DRGSF-P/76-0049

Ref: NRC letter, dated 29 July 1977, subject: Application for Amendment to License No. 29-01022-07.

SUBJECT: Application to Amend NRC License EML 29-01022-07

Figure 12A. Mechanism for source. Source in down (storage) position

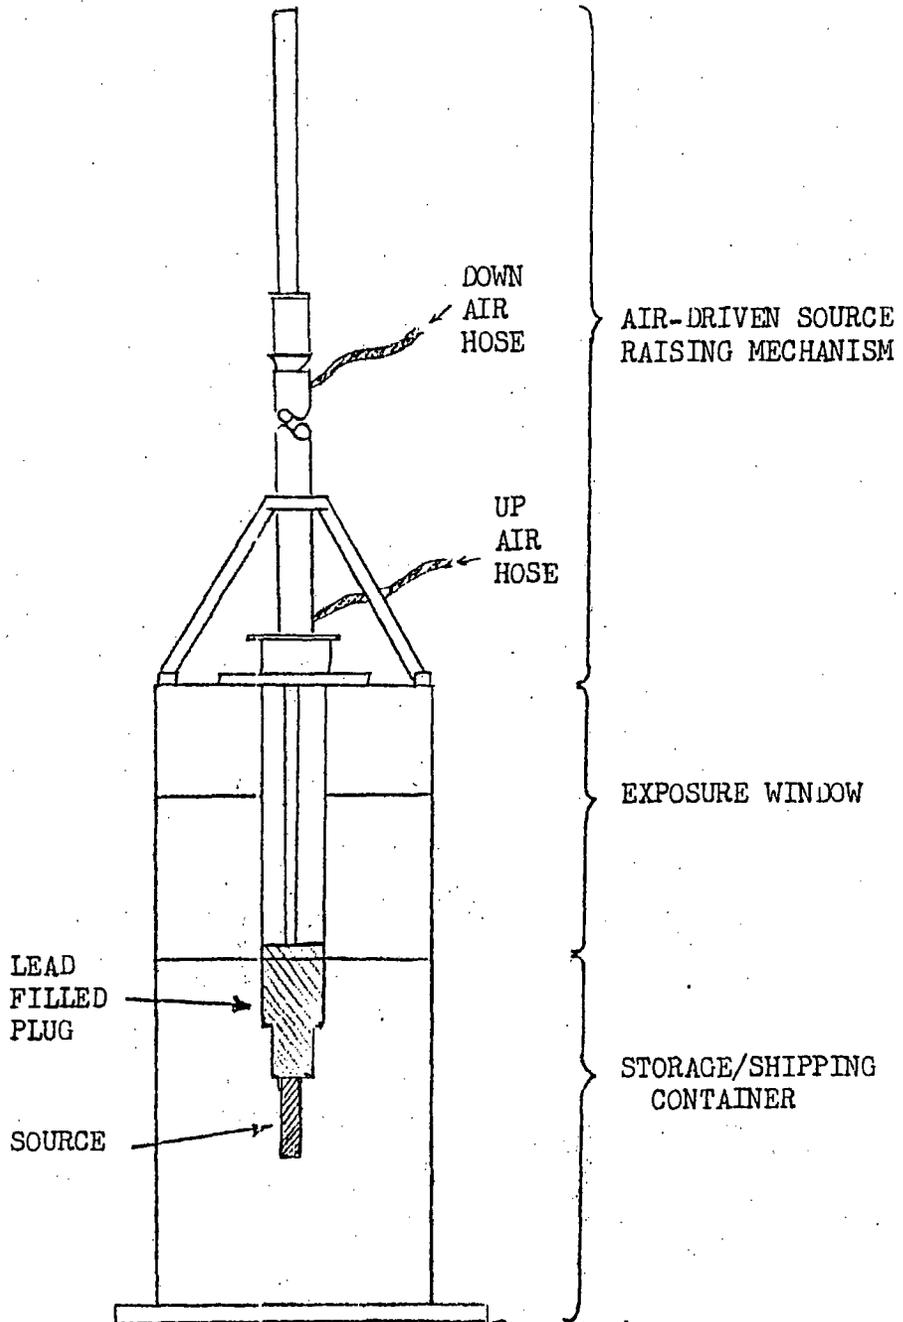
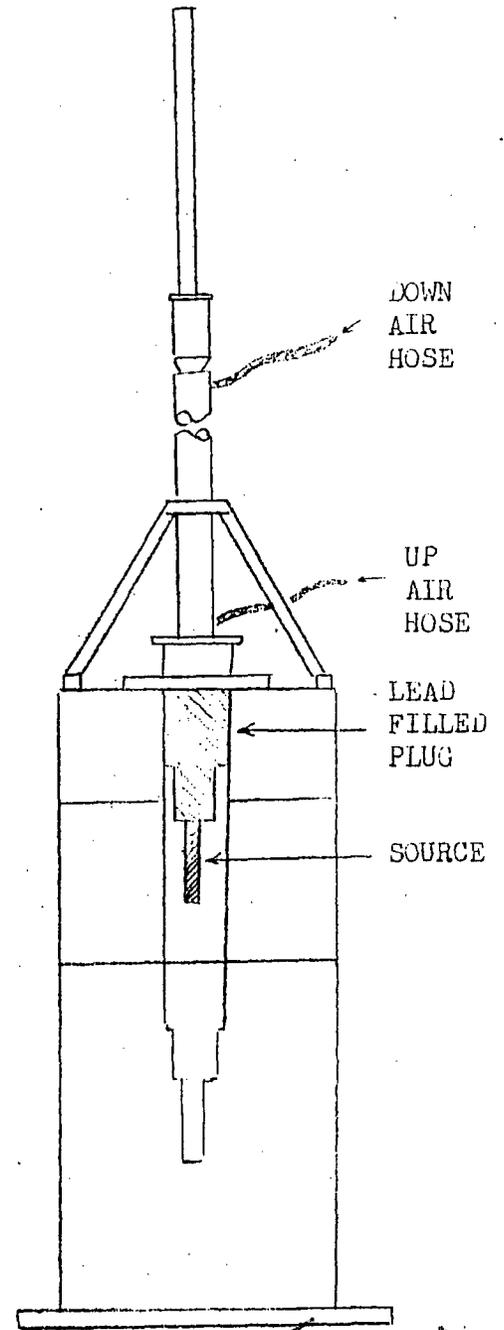
3. The exposure device is illustrated in the sketches of Inclosure 1, which is a replacement for page E-13 of the application for amendment. The exposure device is the same as used under EPL 29-0047-05 at Picatinny Arsenal. A further description is included in para 13 of Incl 2, which is a replacement for page E-1a of the application for amendment.

- 13. The components shown in Figures E-11, E-12a and E-12b and the pneumatic and electrical systems (See Figs. E-9 and E-10) make up the 2048 Ci source storage and use device. The exposure window allows irradiation in an arc of  $110^\circ$ , with 8 inches of lead (encased in  $\frac{1}{2}$  inch of stainless steel) shielding in all other directions. The storage/shipping container is marked as being manufactured by the Edlow Lead Co, Columbus, Ohio, under BE Permit No. 1462. As depicted in Fig. E-9, activation of any of the interlocks cuts the power to the solenoids, resulting in the sources being lowered. In the event of power failure the sources will be automatically lowered the same as an interlock action. In the event of air failure without power failure the source can still be lowered by cutting the power to the solenoids. The weight of the lead-filled plug will force the source into the storage container.

FIG. E-9. PNEUMATIC CONTROL SYSTEM.

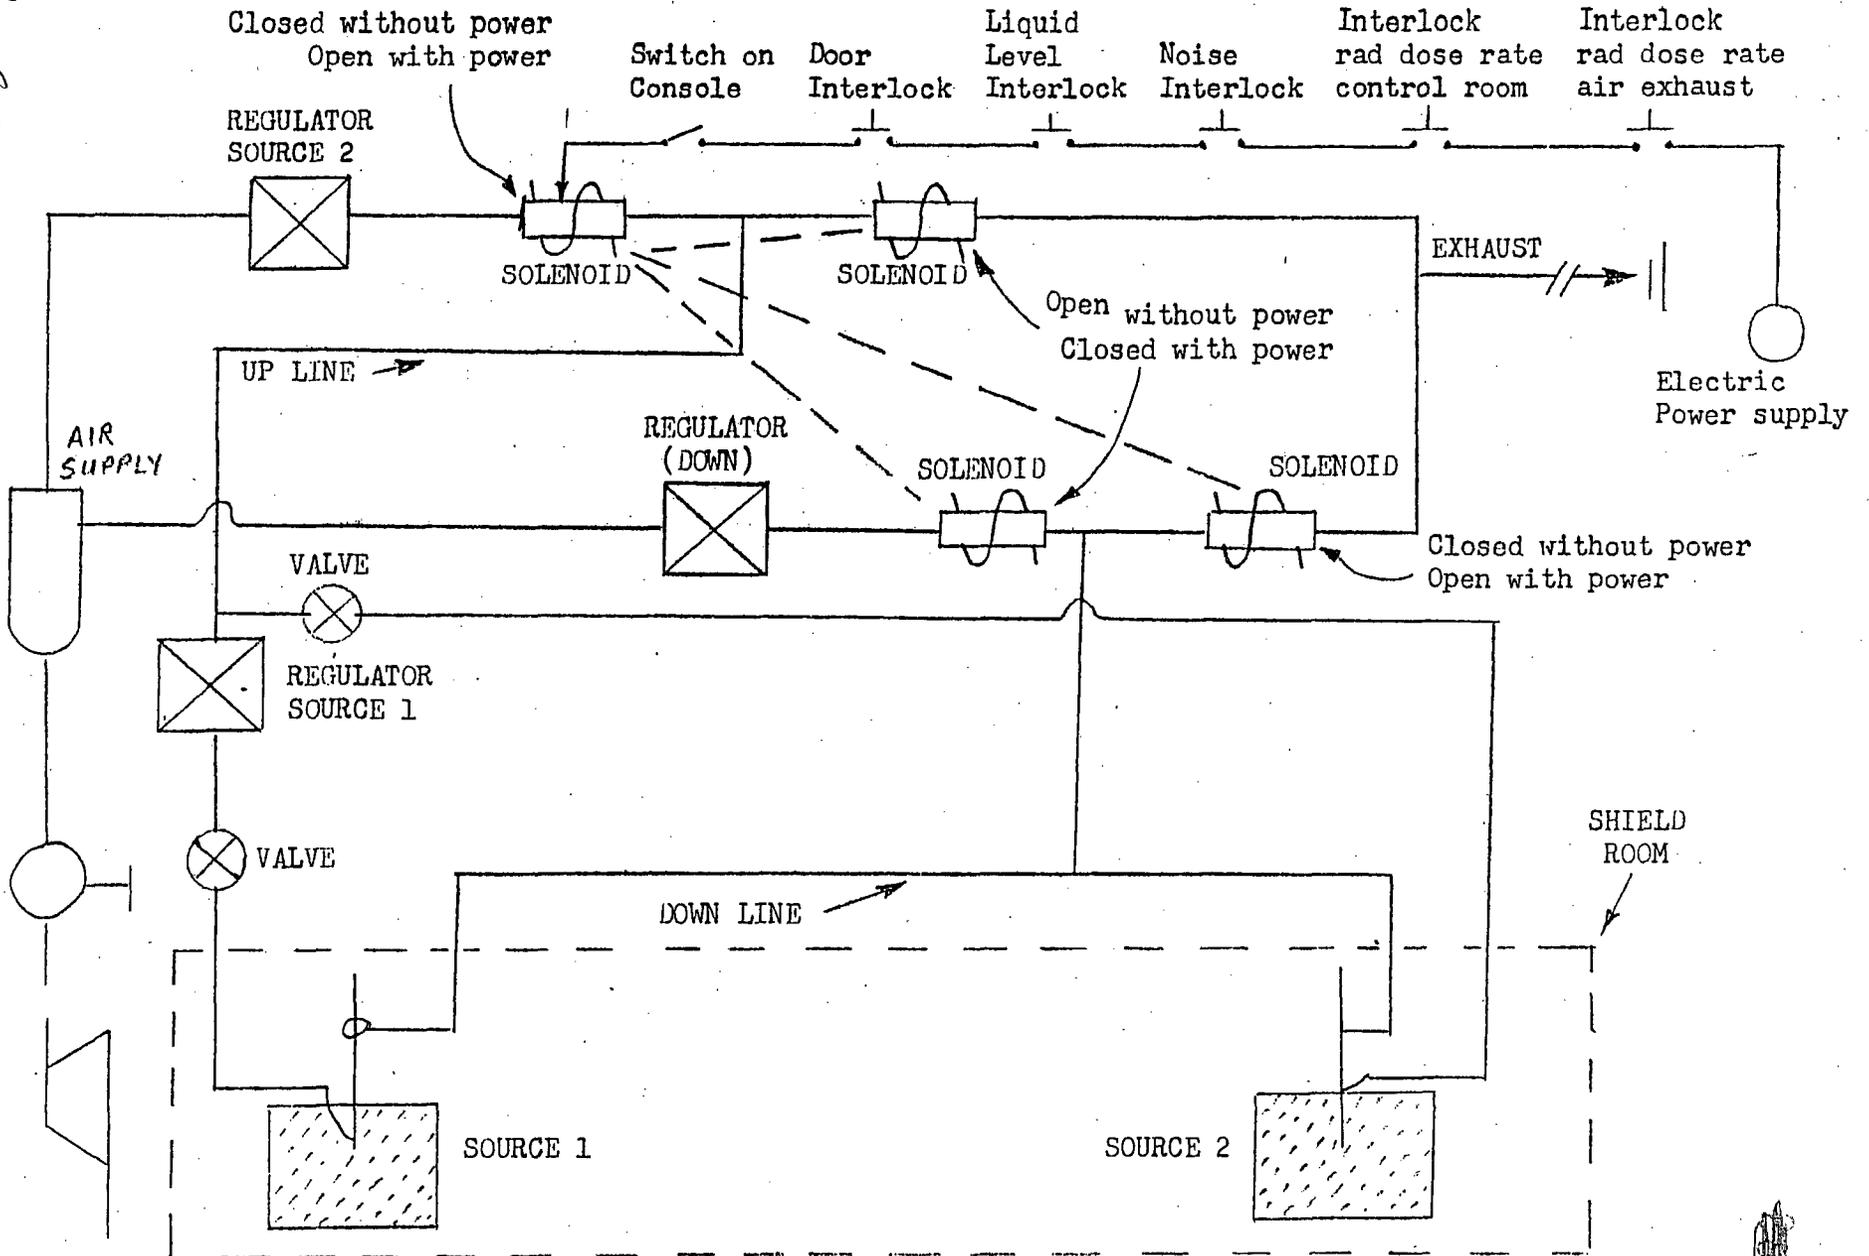
4. The operation of the interlock system is illustrated in Incl 3, which is a replacement for page E-10 of the application for amendment. All solenoids in the pneumatic control system are ganged so that application of power puts each solenoid into its mode for raising the sources and without power each solenoid is in its mode for lowering the sources. Activation of any of the interlocks cuts the power to the solenoids.

- 12. The pneumatic control system is shown in Fig. E-9. The hand operated valves (in the Console Room) in the up line allow either or both sources to be raised for use when the system is in operation. An emergency generator and air compressor take over automatically in case of an interruption or failure of the electrical power system.
